# Memorandum

<b>Project:</b>	Jericho Project Advisory	<b>File No.:</b>	04006
<b>From:</b>	Rick Pattenden	<b>Date:</b>	29 November 2004
<b>To:</b>	Derrick Moggy, Fisheries and Oceans Canada	<b>Page:</b>	1 of 3
<b>cc:</b>	Dan Johnson and Greg Missal, Tahera Diamond Corporation		
<b>Re:</b>	Response to DFO –Channel design

Detailed design drawings are presented in Appendix X - SRK Tech. Memo W, Drawings W- 2 and W-3. A revised design drawing W-2A that illustrates the details of the riffle-pool complexes to be incorporated into the diversion channel is attached.

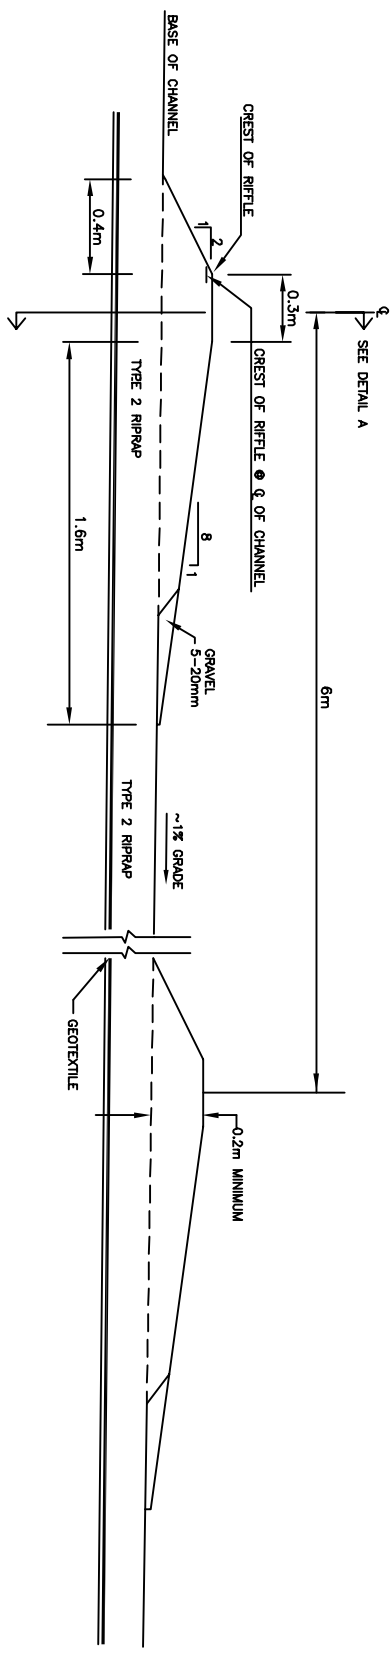
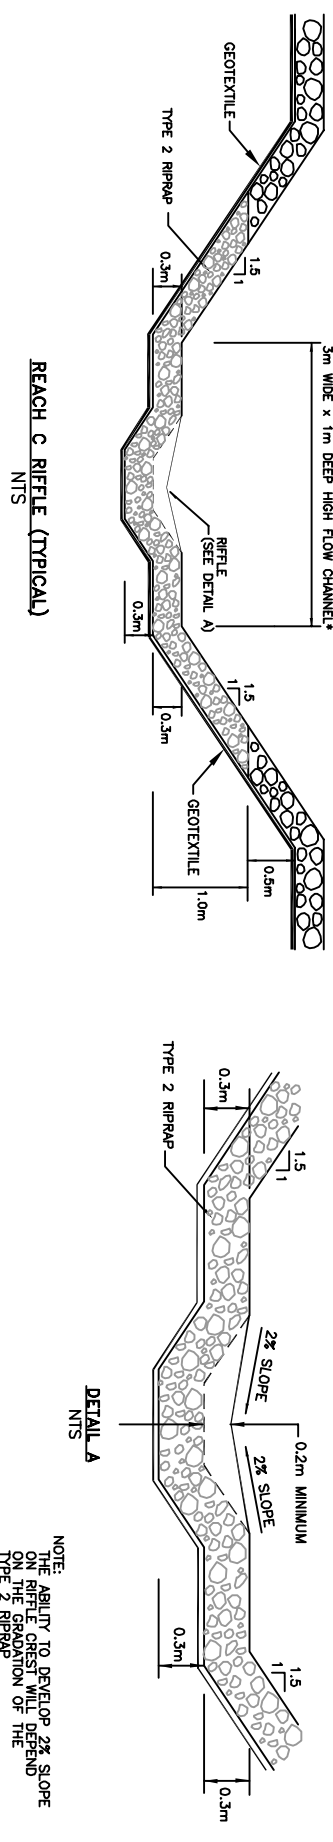
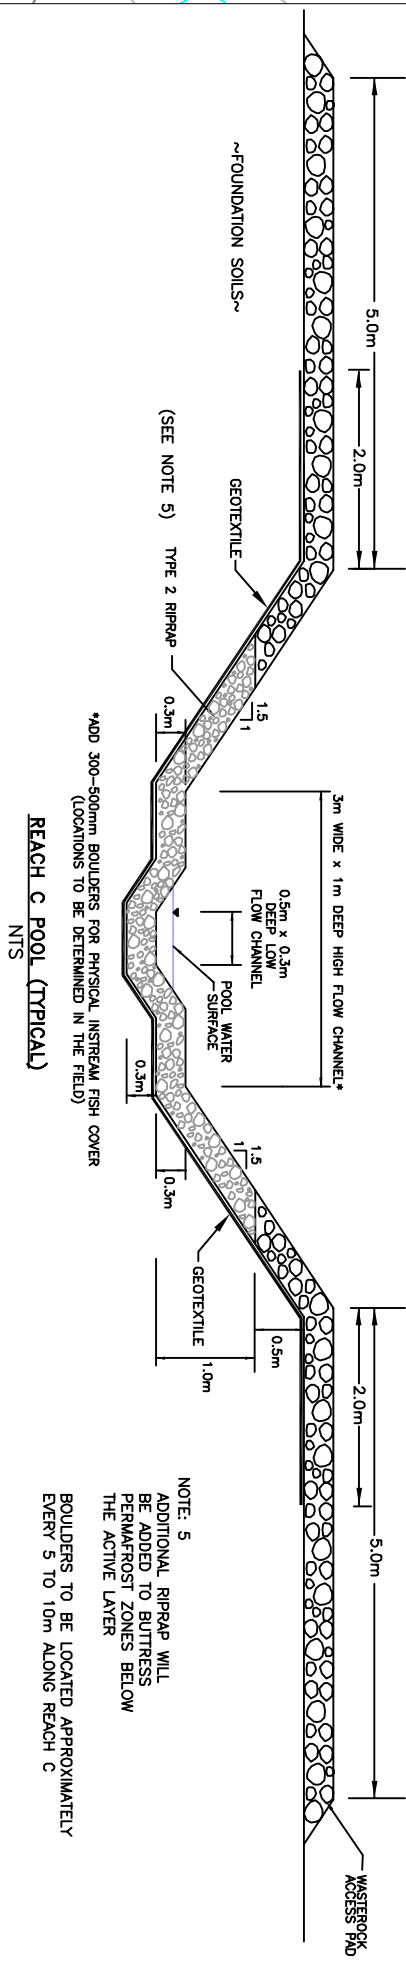
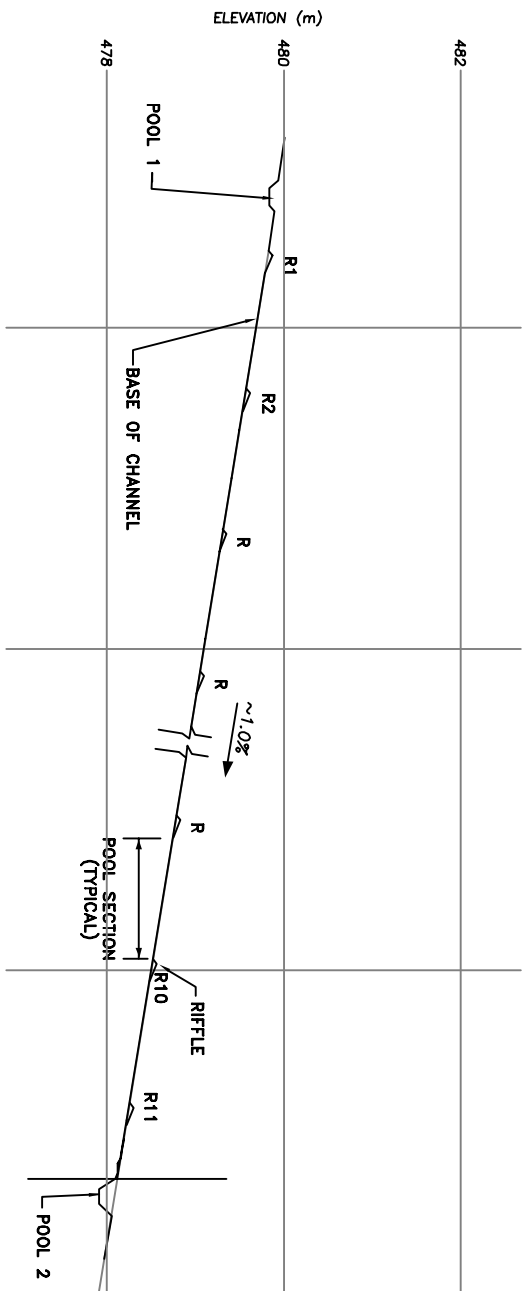
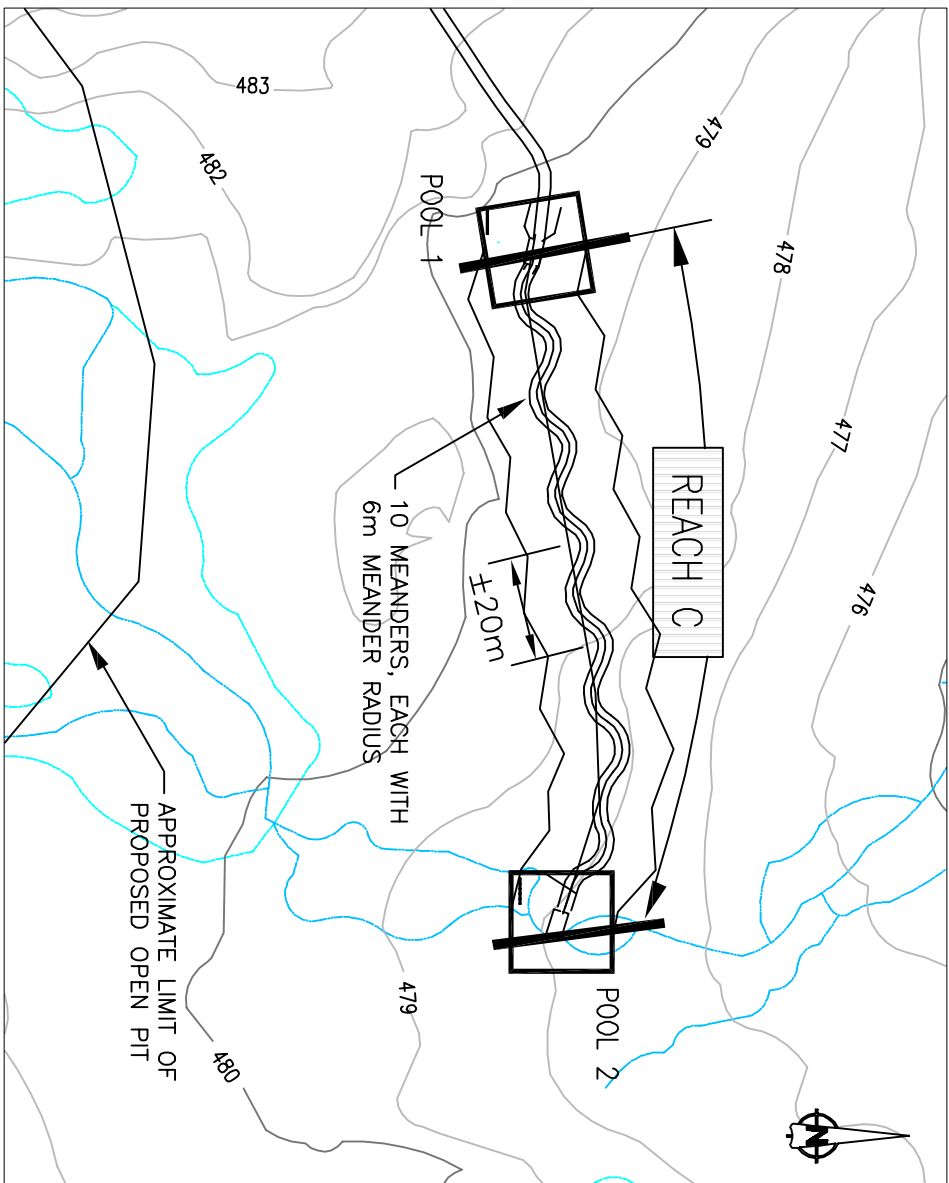
2. Channel design – Due to the concerns with long-term water quality at closure, TDC has agreed that the diversion channel will be designed for long-term use. DFO supports this approach as well as the commitment to design the diversion channel to accommodate fish habitat characteristics typical of adjacent natural channels. In addition to the meanders and low flow channel, the incorporation of pools is also favourable as this would improve habitat diversity in Stream C1, given the limited pool habitat. However, due to the uncertainty associated with permafrost, DFO is concerned the 1 metre depth in the pool design over such a width may result in degradation of the pool. As a result, it would be beneficial to determine whether a narrow, longer pool would provide the same function as the wide pool. In addition, it is acknowledged that there is a general lack of baseline fisheries data previous to the construction of the berm, and therefore it is uncertain as to the extent of fish passage to upstream sections. Therefore, it would be favorable to improve the connection to the lower section, provided permafrost will not be an issue and the impacts due to blasting can be mitigated (i.e. incorporation of a temporary cofferdam until blasting distance is adequate). During DFO's site visit, it was apparent that riparian vegetation does well along the upper section of Stream C1 and will be a key component missing in the new channel. Since the diversion is being designed, the feasibility of incorporating riparian vegetation along the banks should be investigated.

Next Steps: Please provide TDC's commitment to design the channel for long-term use, incorporating natural channel design principles such as meanders, low flow channels, as well as the feasibility of incorporating long, narrow pools, improved access to downstream habitat and riparian vegetation. Furthermore, **DFO will require detailed design drawings for review**, although a timeline on this provision would be sufficient the purposes of the NWB Hearing.

Tahera is committed to designing a channel for long-term use, incorporating natural channel design principles (i.e., meanders, low flow channels, and riffle-pool complexes), as well as investigating the feasibility of incorporating long, narrow pools, and riparian vegetation.
